PRAIRIE ISLAND NUCLEAR GENERATING PLANT UNIT NO. 1

Amendment No. 61
License No. DPR-42

ATTACHMENT TO LICENSE AMENDMENTS

Replace the following pages of the Appendix A Technical Specifications with the enclosed pages as indicated. The revised pages are identified by amendment number and contain vertical lines indicating the area of change.

FIGURE TS.6.1-1 NSP CORPORATION ORGANIZATION RELATIONSHIP TO ON-SITE OPERATING ORGANIZATIONS

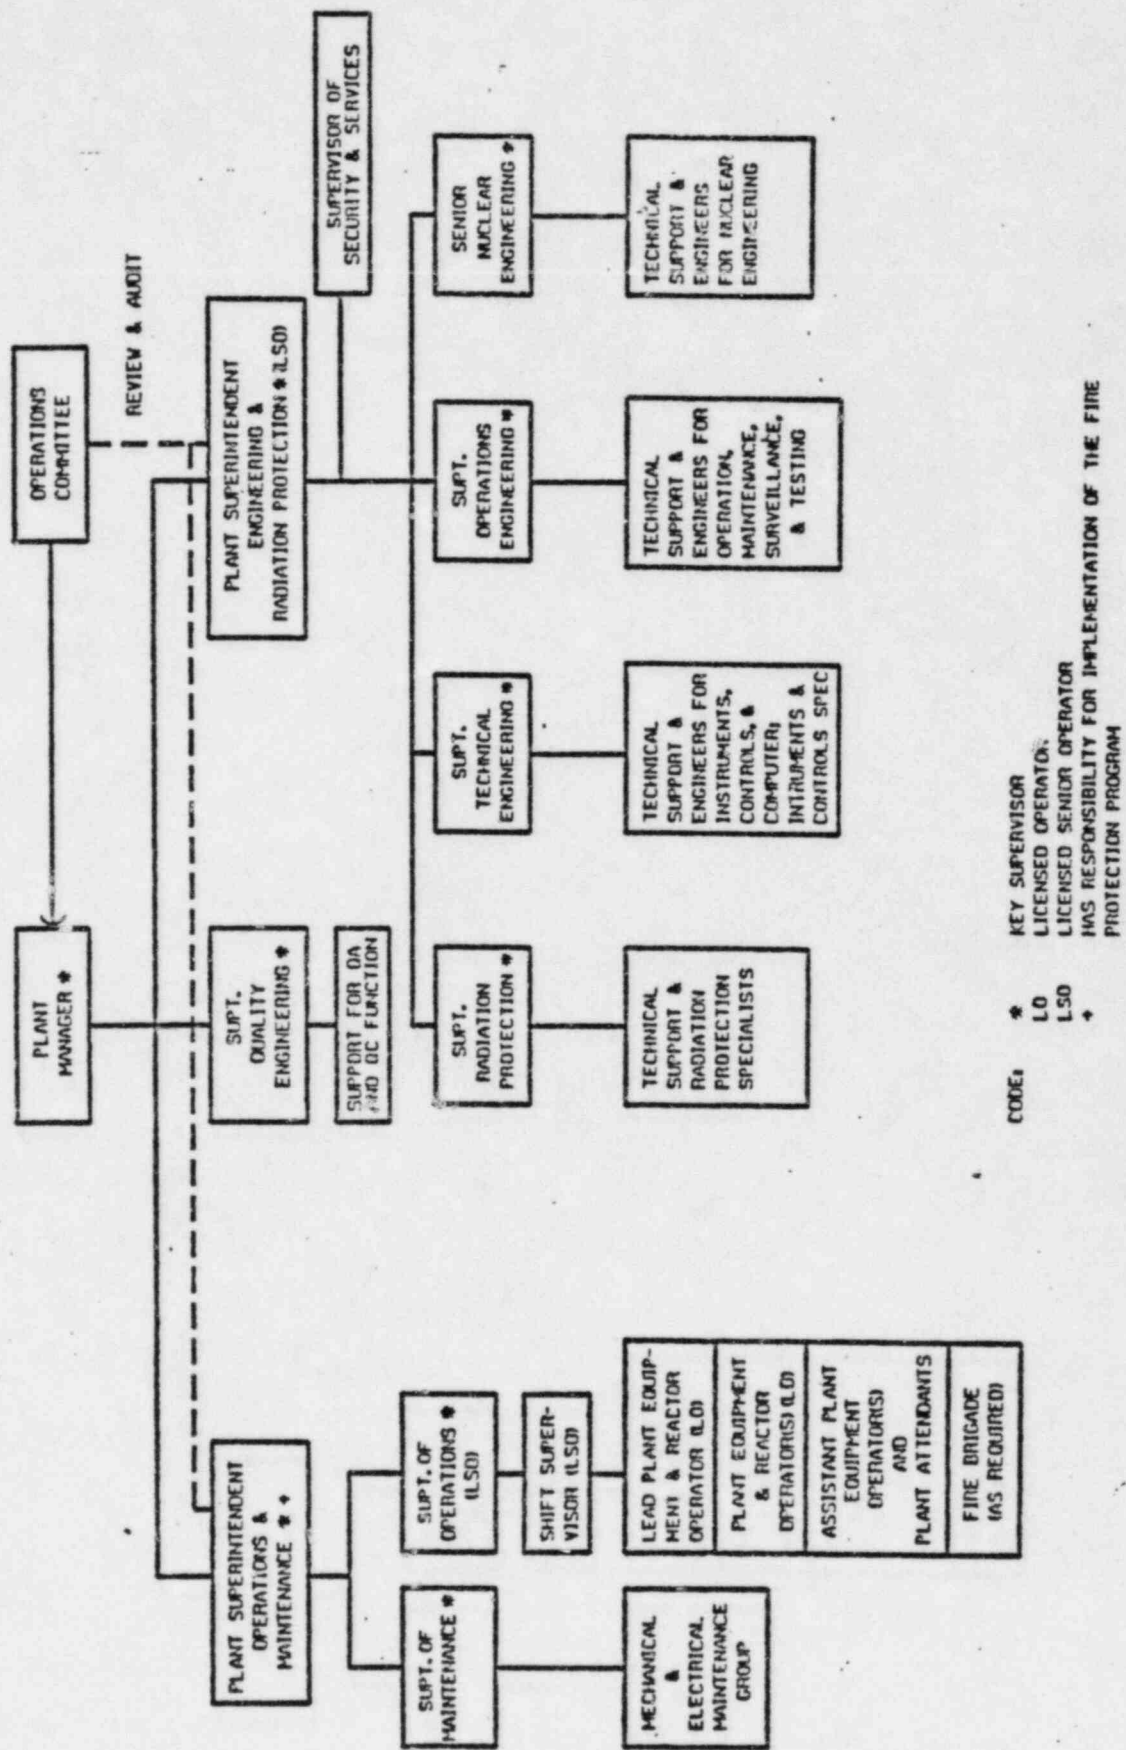
- B. The Northern States Power corporate organizational structure relating to the operation of this plant is shown on Figure TS.6.1-1.
- C. The functional organization for operation of the plant shall be as shown in Figure TS.6.1-2 and:
